**CITY OF LACONIA**  
**REGULAR PLANNING BOARD MEETING**  
**Tuesday, January 6, 2026 - 6:30 PM**  
**City Hall - Armand A. Bolduc City Council Chamber**

**6.1. PB2026-021; 604 Endicott St N (128-252-3.1)**

Re: 604 Endicott St N, Laconia Site Plan

I have reviewed the revised Site Plan and Stormwater Management Analysis Report for 604 Endicott St N, known as Tiki Plaza. The revision date listed on these documents is January 13, 2025.

Figure 1: Route 3 Flow

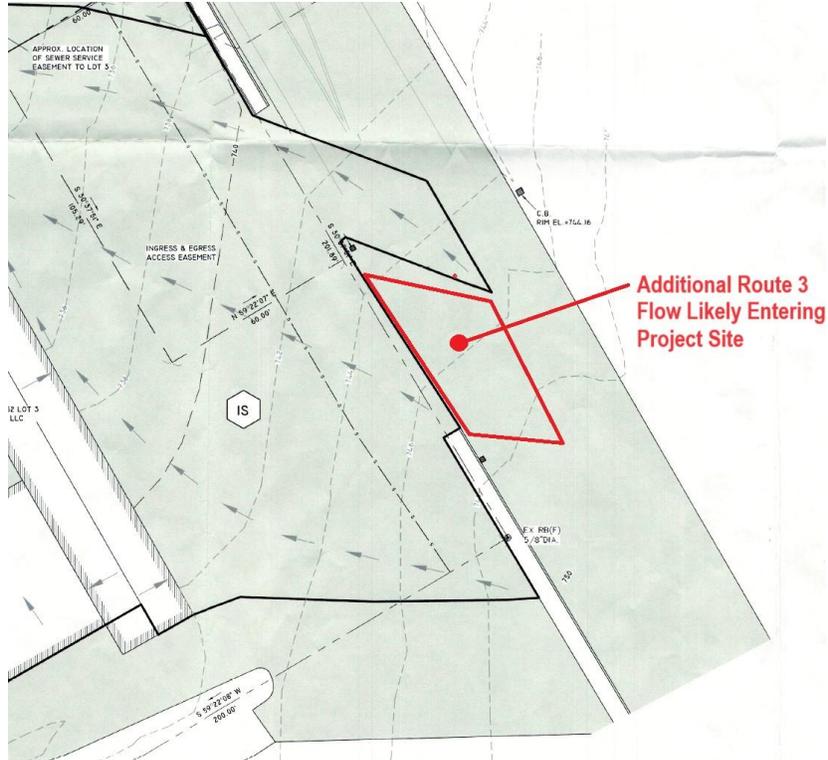
1. As stated previously, the hydrologic model appears to underestimate the area of Route 3 flowing onto 604 Endicott St N. No additional area was added to the revised stormwater calculations to account for this flow from Route 3. The existing and proposed flows onto 554 Endicott St N are likely slightly underestimated by the model. See Figure 1 and Figure 2 on the following page:

Figure 3: Rear Gravel (Existing Conditions Plan)

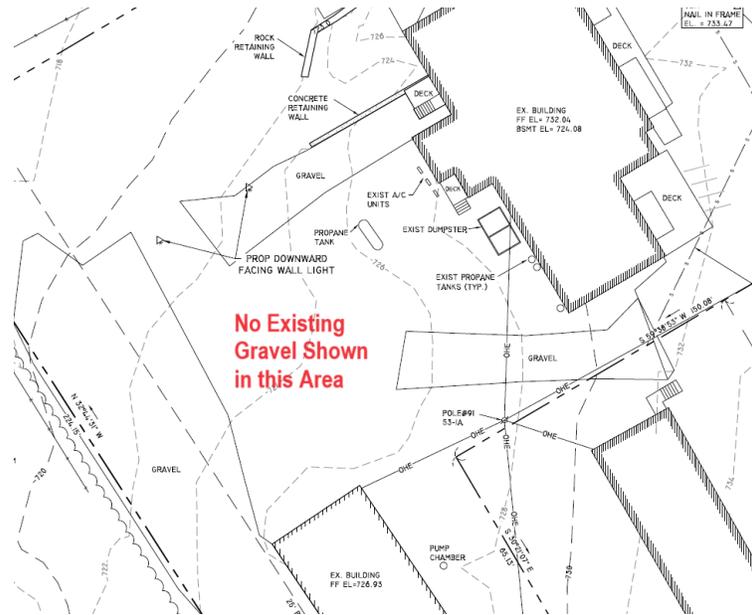
2. As stated previously, the Pre-Condition map depicts approximately 4,000 sq ft of existing gravel area that is not depicted on the Existing Conditions plan. This area was not added to the pre-development drainage model. If this gravel area does not exist then the model likely calculates the existing flows to be higher than they actually are. This, in turn, may result in proposed flows that are higher than the actual existing flows.

Figure 1: Route 3 Flow

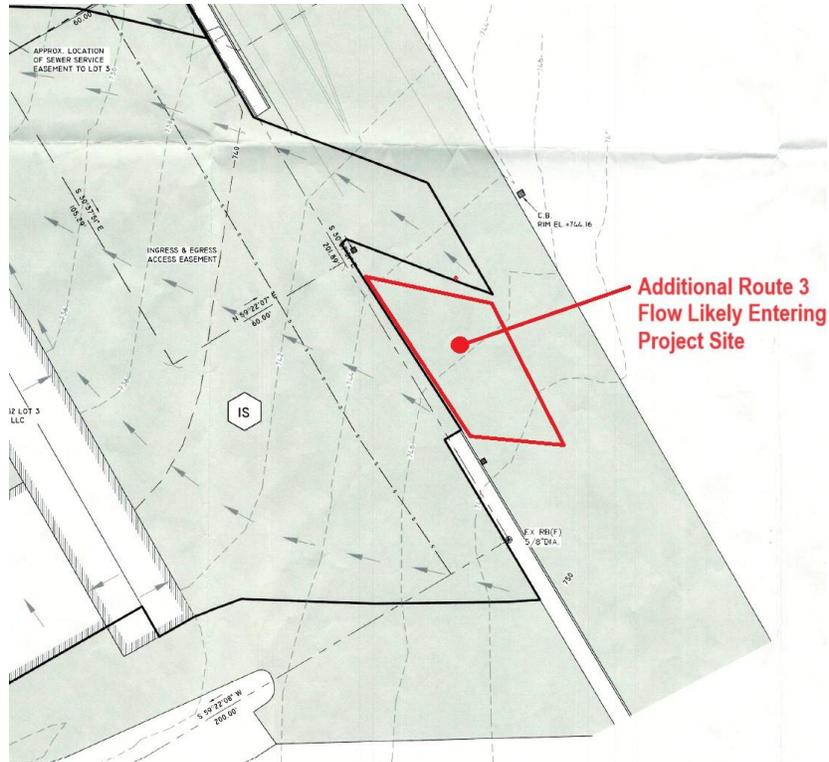
1. As stated previously, the hydrologic model appears to underestimate the area of Route 3 flowing onto 604 Endicott St N. No additional area was added to the revised stormwater calculations to account for this flow from Route 3. The existing and proposed flows onto 554 Endicott St N are likely slightly underestimated by the model. See Figure 1 and Figure 2 on the following page:

Figure 3: Rear Gravel (Existing Conditions Plan)

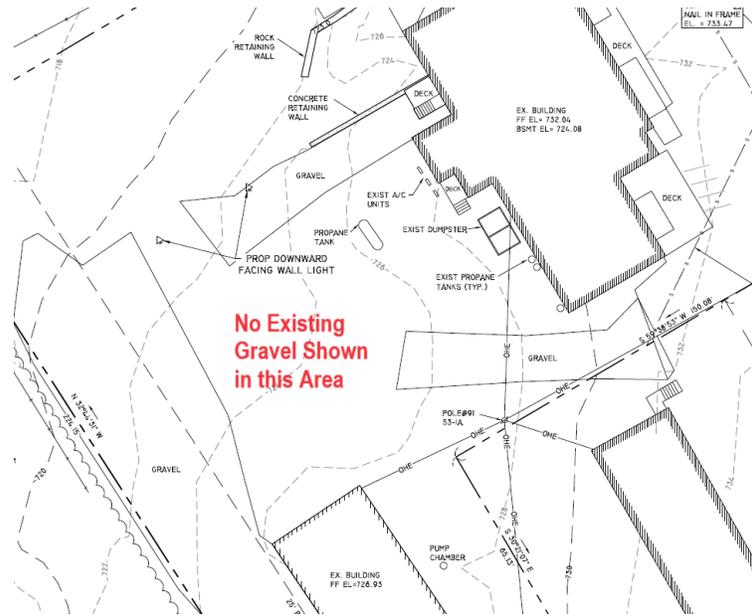
2. As stated previously, the Pre-Condition map depicts approximately 4,000 sq ft of existing gravel area that is not depicted on the Existing Conditions plan. This area was not added to the pre-development drainage model. If this gravel area does not exist then the model likely calculates the existing flows to be higher than they actually are. This, in turn, may result in proposed flows that are higher than the actual existing flows.
